PLANNING BOARD REPORT PORTLAND, MAINE

Seaport Lofts (Bay House Phase II)
101-121 Newbury Street and 40 Hancock Street
Level III Site Plan and Subdivision Review
2013-179
113 Newbury Street, LLC, Applicant

Submitted to: Portland Planning Board Public Hearing Date: September 24, 2013 Planning Board Report Number: #42-13	Prepared by: Nell Donaldson, Planner Date: September 20, 2013 CBLs: 20-D-13, 14, 15, 32
--	---

Figure 5: Proposed Hancock Street elevation

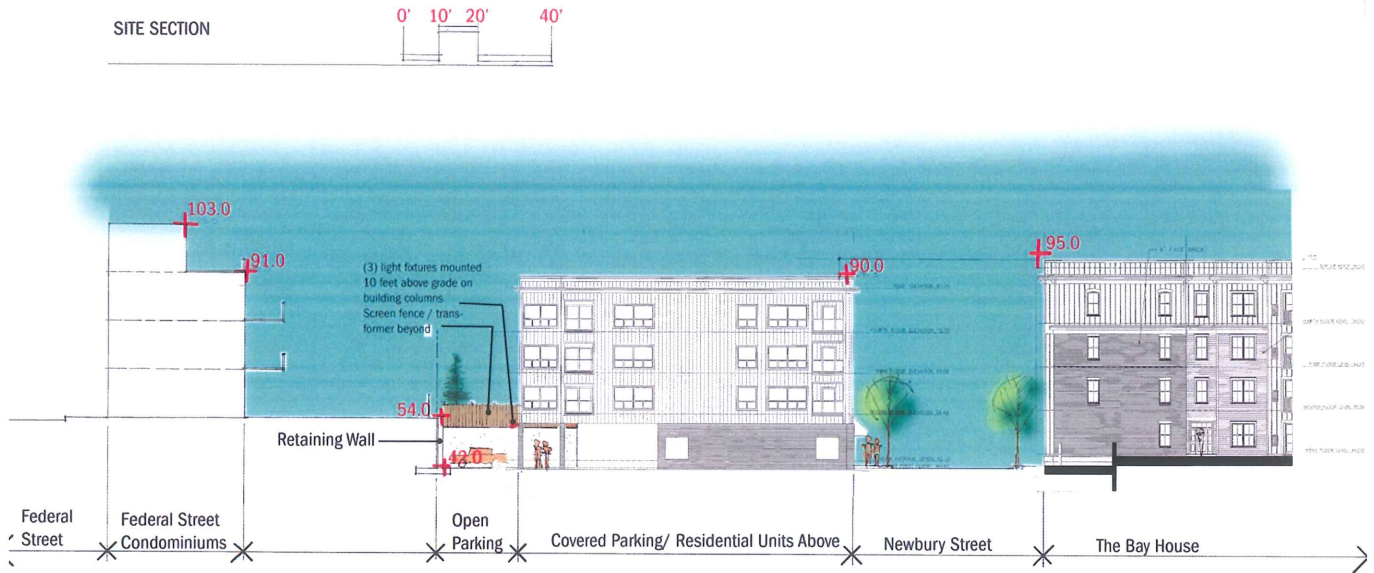
As noted in the prior memo to the Board, Seaport Lofts is proposed as a four-story building. The application states that it will not exceed the 45’ height limit, and the final elevations show a height of 44.9 feet. Verification of the proposed building height is outstanding.

Figure 5 below shows the proposed Hancock Street grade elevations. Much of the shadow impact from the Seaport Lofts would fall on the northerly residential buildings, although this would be mitigated slightly by the elevation change toward Federal Street. There would be no shadow impacts to publicly accessible open spaces. Per the Technical Manual, a shadow study is not required for Level II or III developments that are less than 45 feet tall (*Section 11.3*). Though the height remains to be verified by the zoning administrator, it is the applicant’s intent that the building meet the zoning height limit.
